Other Change to an Existing Approval

Application No:	MCU/12/0017
Street Address:	936 Tinaroo Creek Road, Mareeba
Real Property Description:	Lot 358 on OL451
Planning Scheme:	Mareeba Shire Council Planning Scheme 2016

Type of Approval: Development Permit for Material Change of Use – High Impact Industry (Concrete Batching Plant) (Formerly Defined as Industry)

936 Tinaroo Creek Road, Mareeba
Request for 'Other Change' (MCU/12/0018)

936 Tinaroo Creek Road, Mareeba
Request for 'Other Change' (MCU/12/0018)
TRAFFIC IMPACT REVIEW

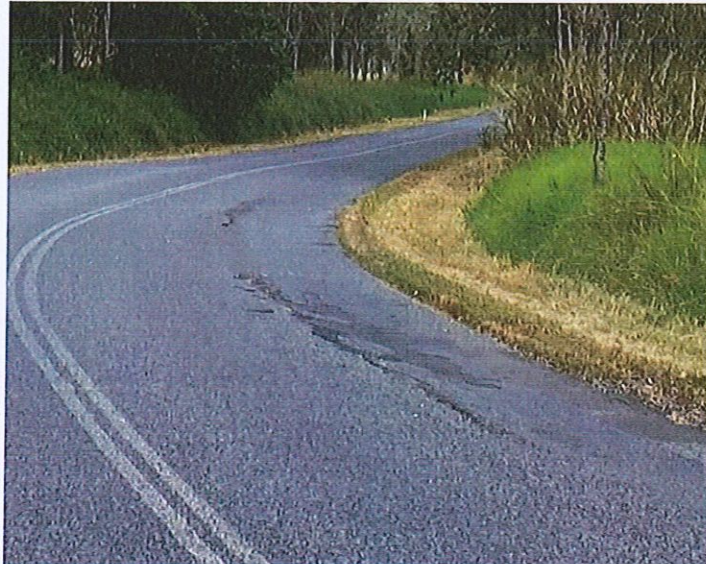
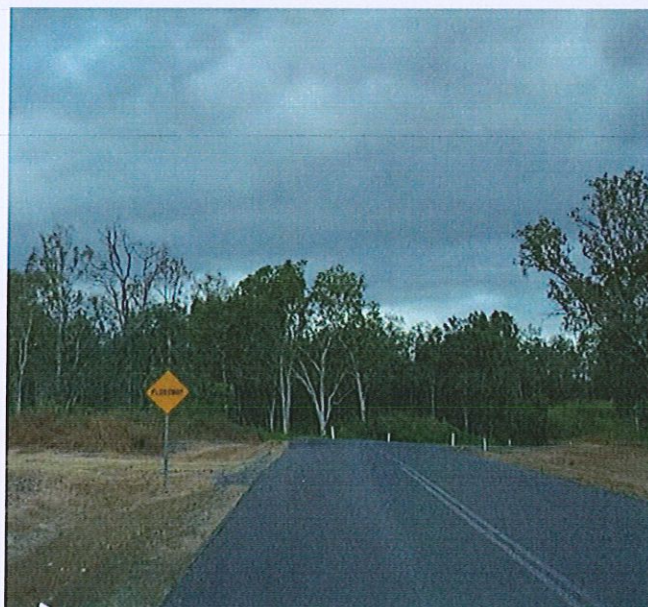
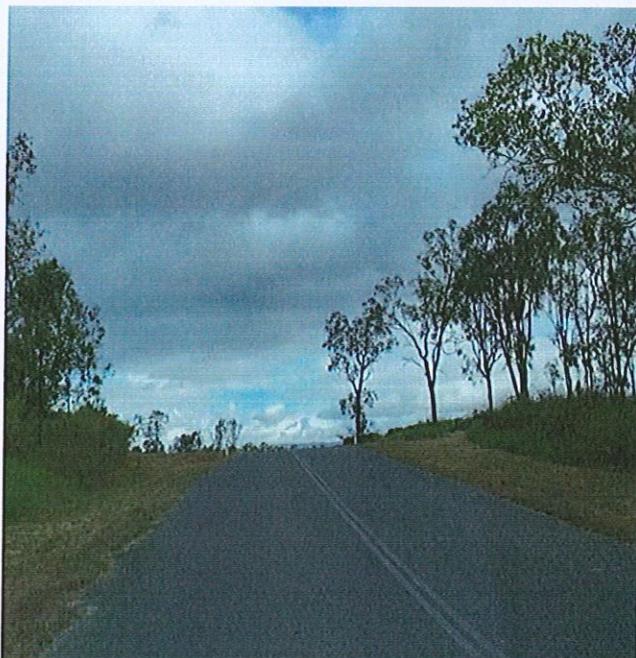
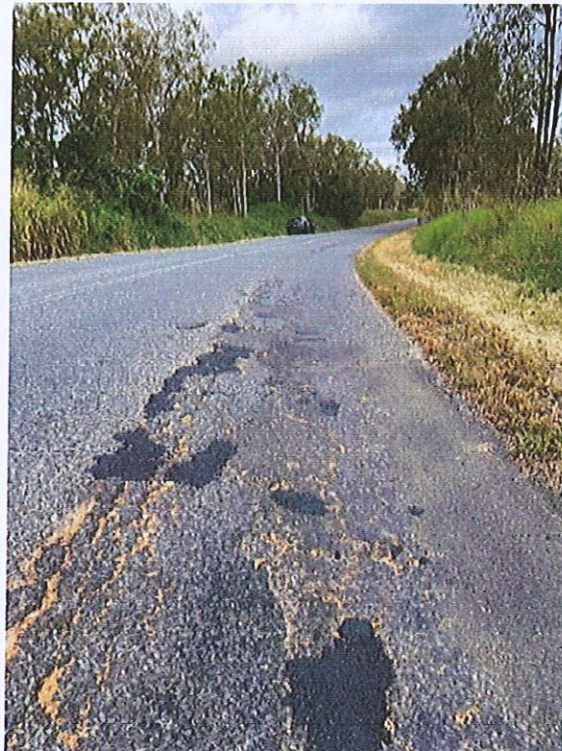
The photos show examples of key locations where sightlines were restricted due to tight bends and crests. As detailed in the report there are a number of locations which could benefit from an assessment of the geometry to ensure pavement width and warning signage is in accordance with relevant standards.

Included are also photos of some examples where there is evident pavement damage, primarily on the bends where heavy vehicles regularly turn. It is acknowledged that these defects are not solely attributed to the traffic generated by the concrete plant, however it is reasonable to assume that the unauthorised level of traffic associated with its operations could have had some level of contribution to the deterioration of the pavement at these locations.
